**Illustrative Site Plan**

99-41(c)

**CHARLOTTE - MECKLENBURG PLANNING COMMISSION**  
**INTER - OFFICE COMMUNICATION**

SUBJECT: Administrative Approval for Petition No. 99-41(c) by John Wayne and Hester Adams.

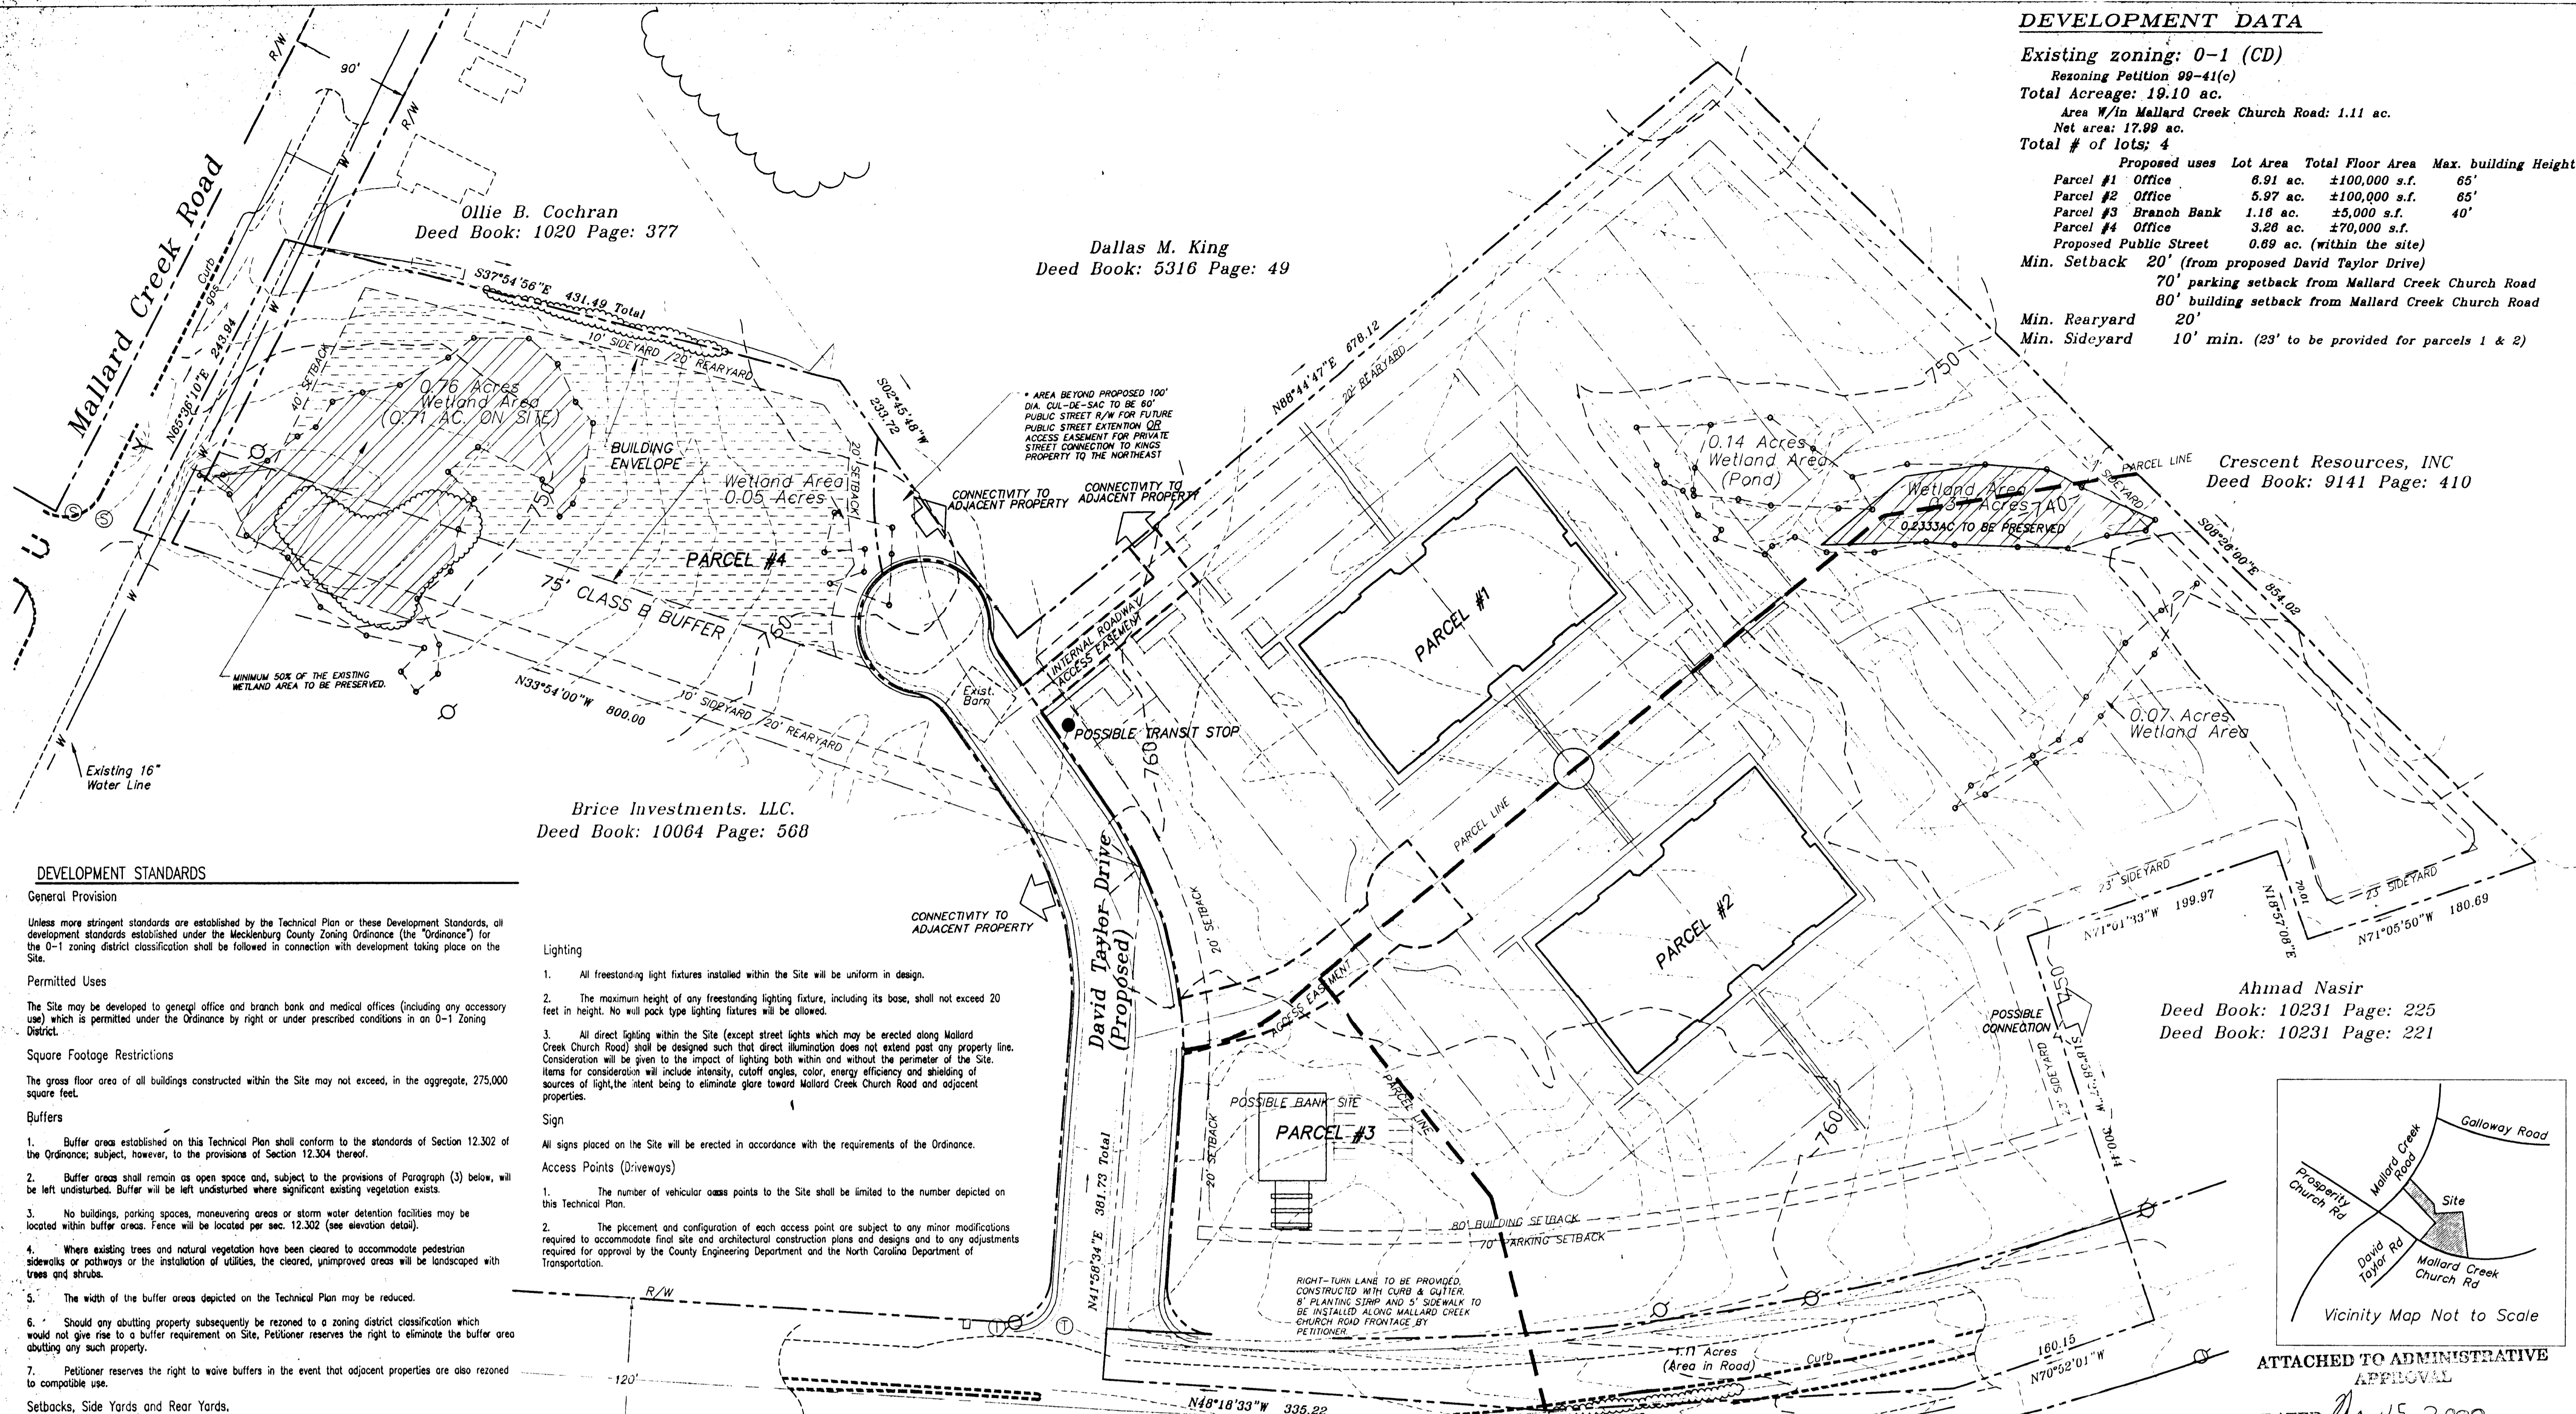
Attached is a revised site plan for the above petition. The plan has been revised to add a public road from Mallard Creek Church Road, delete the access point from Mallard Creek Road and eliminate buffer requirements adjoining recently rezoned properties. This request does not change the allowable square footage approved for this site. Since these changes are minor and do not alter the intent of the approved plan I, an administrator, approving this revised plan. Please use this plan when evaluating requests for building permits and certificates of occupancy.

Mallard Creek Church Road  
Business Park  
for  
High Associates  
Illustrative Site Plan

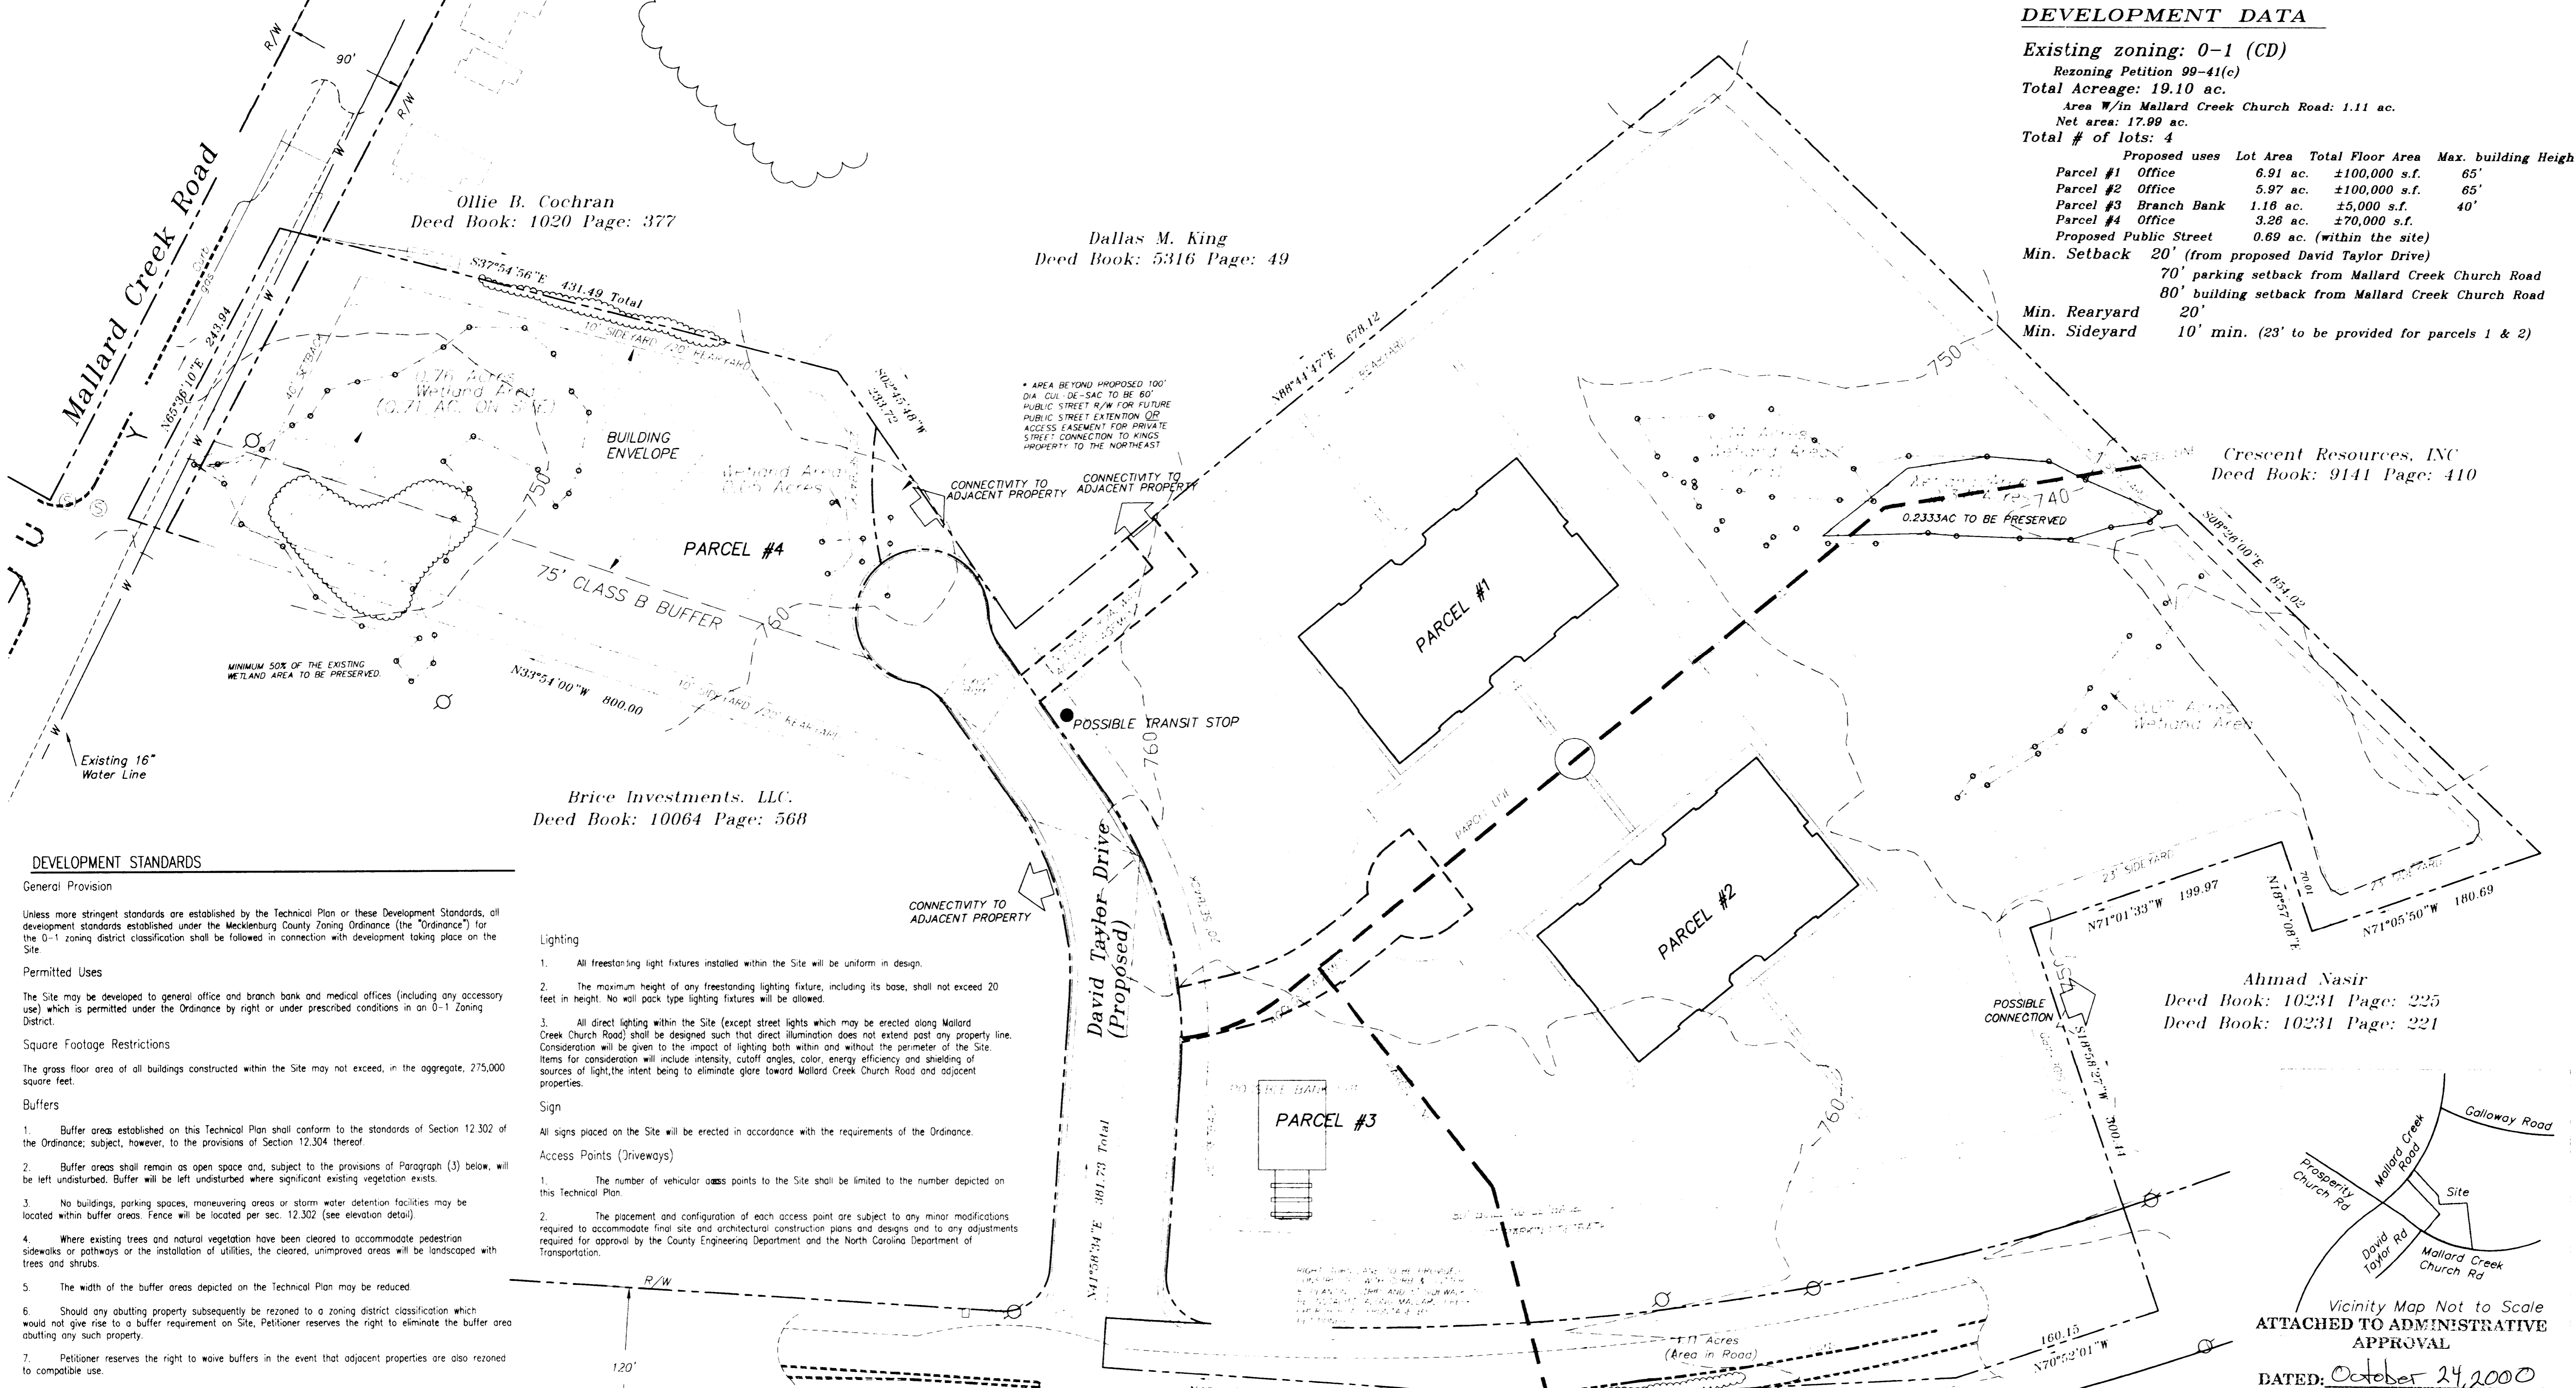
Attached is a revised site plan for the above petition. The 80-foot setback along Mallard Creek Church Road has been revised to allow a row of small maturing trees along the roadway to deal with overhead line conflicts. This request does not change the allowable square footage approved for this site. Since this change is minor and does not alter the intent of the approved plan I, am administratively approving this revised plan. Please use this plan when evaluating requests for building permits and certificates of occupancy.

ATTACHED TO ADMINISTRATIVE APPROVAL

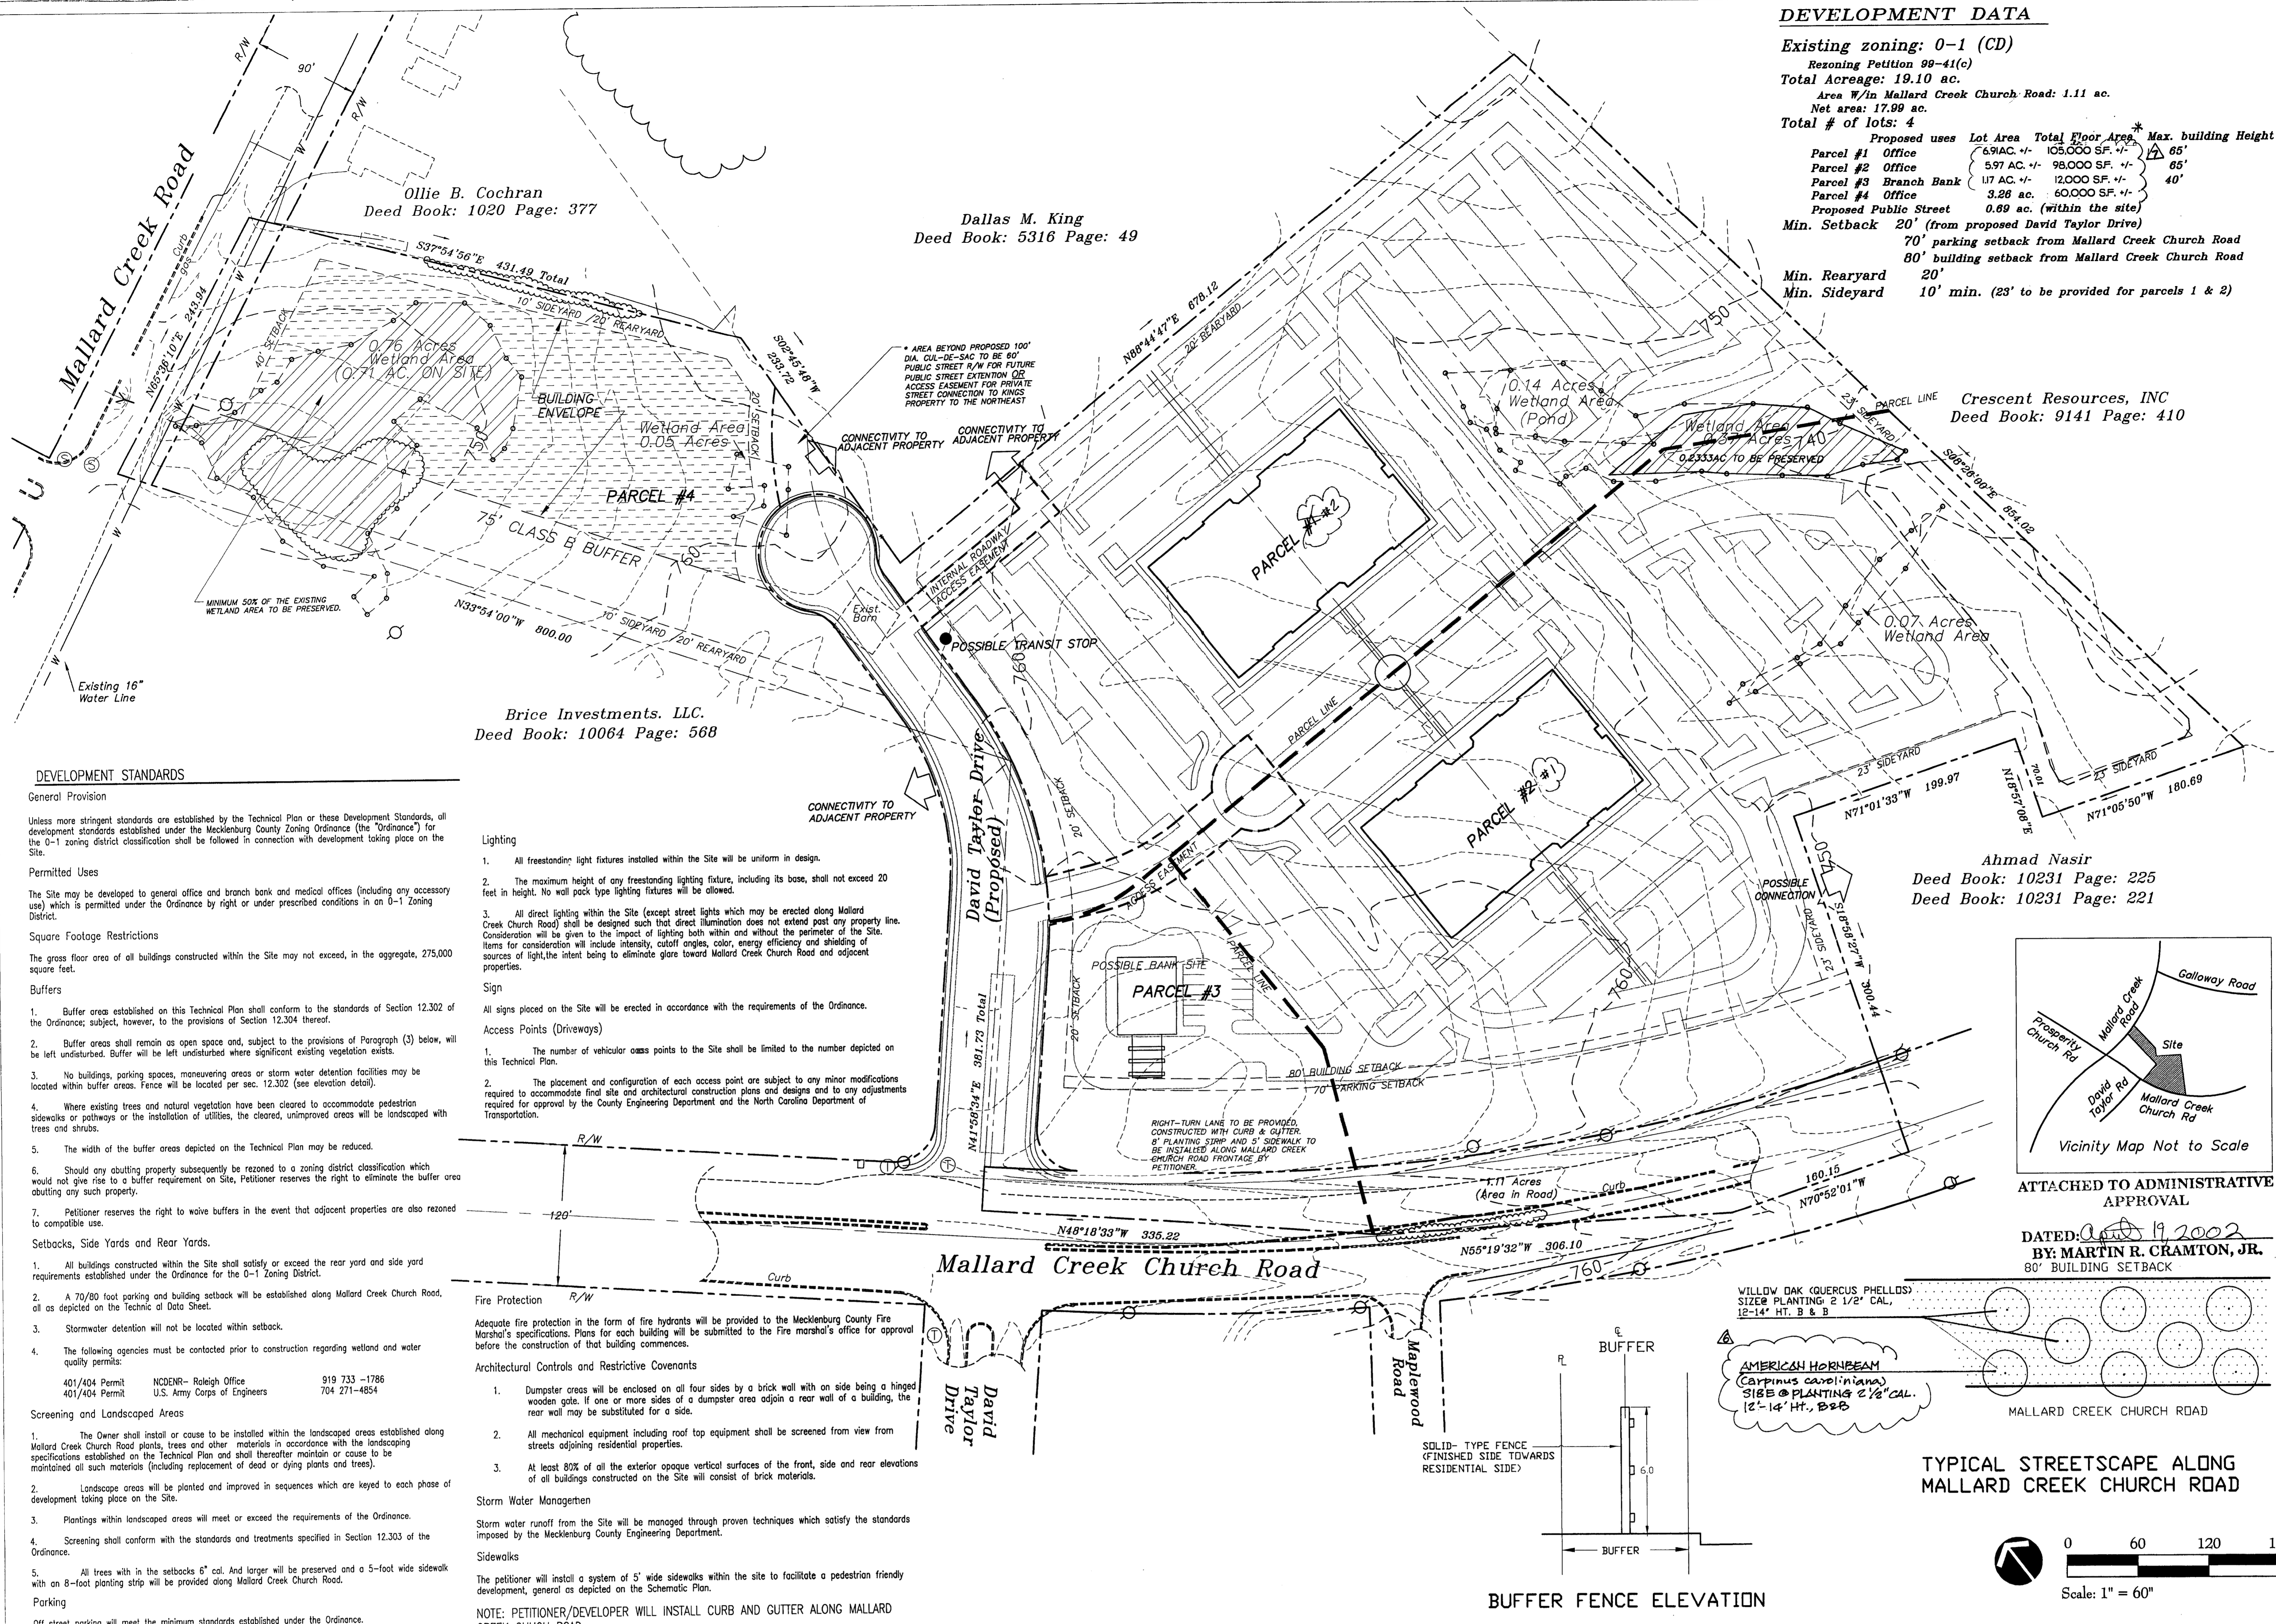
Attached is a revised site plan for the above petition. The plan has been revised to reallocate allowable square footage within the four parcels. This will not increase the total allowable square from the presently approved 275,000. Since this change is minor and does not alter the intent of the approved plan I, an administratively approving this revised plan. Please use this plan when evaluating requests for building permits and certificates of occupancy.
